**From:** Dominic Gothard <[REDACTED]>  
**Sent:** 24 February 2020 22:59  
**To:** Anita Gardner <[REDACTED]>  
**Subject:** Little Deerswood Planning Application - K/32/18/PL (Resent with additional attachment)  
**Importance:** High

I am the owner of Spring Tide the neighbouring house immediately to the east of Little Deerswood.

As with the previously refused application (K/7/19/PL) we write to outline our objection to the application in the strongest possible terms

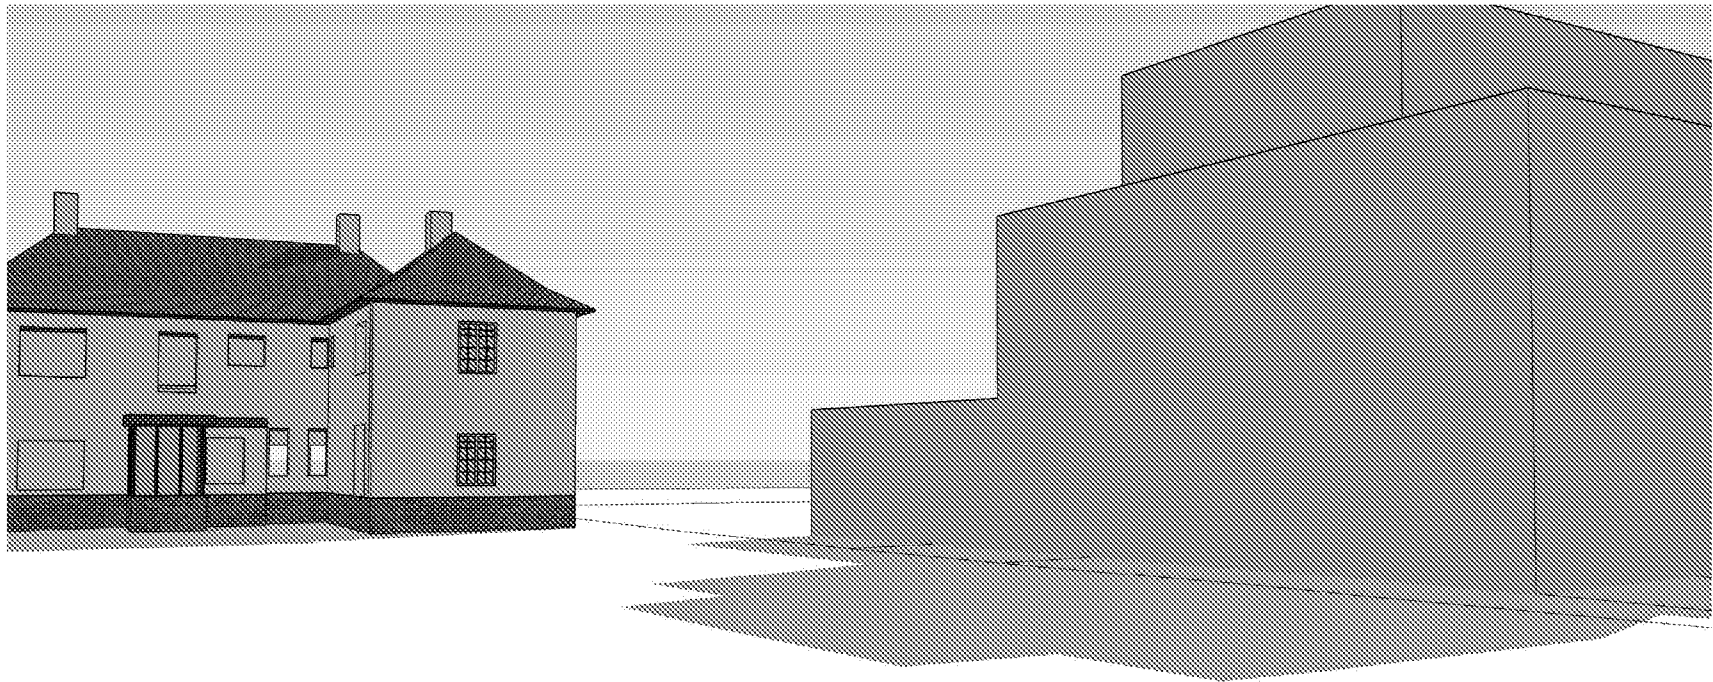
The applicant has made little attempt to mitigate the impact that the house will have on our plot. As with the previous application, the proposed 3 storey form will create an oppressive and acutely overbearing presence on our front garden.

A 3D massing model has been prepared to give a more realistic impression of the relationship between the 2 properties. As with the previous application, these drawings are conspicuous by their absence and it is unfortunate that the applicant has chosen to omit any information which would highlight this completely inappropriate relationship.

Equinox 2:30pm

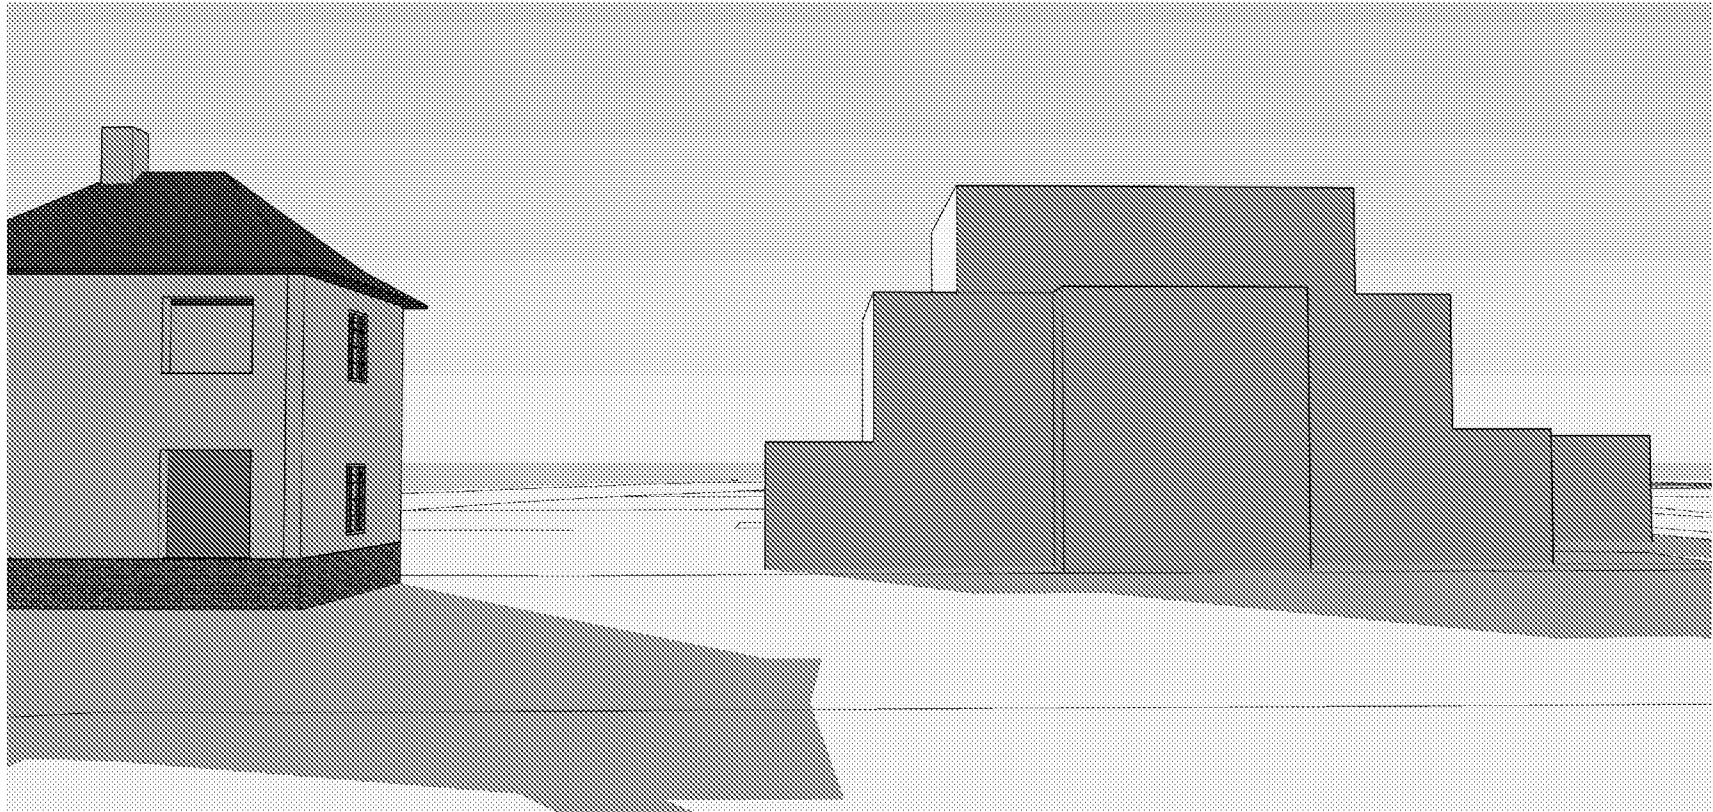
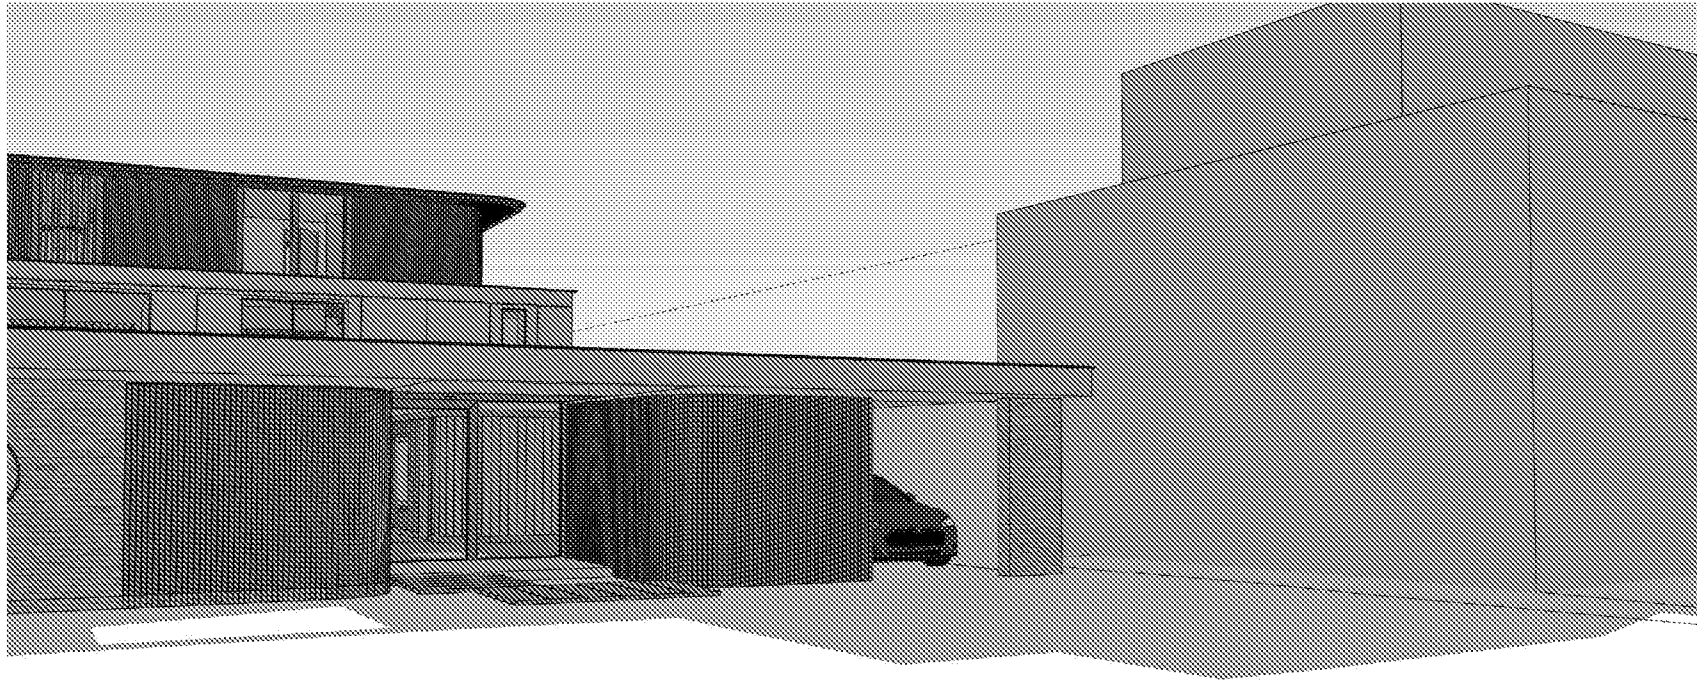
Aside from a small token projection, the east elevation is a sheer 3 storey form that will be visually oppressive and that will completely overshadow the front part of our garden for 6 months of the year from 2pm onwards - see attached shadow diagram.
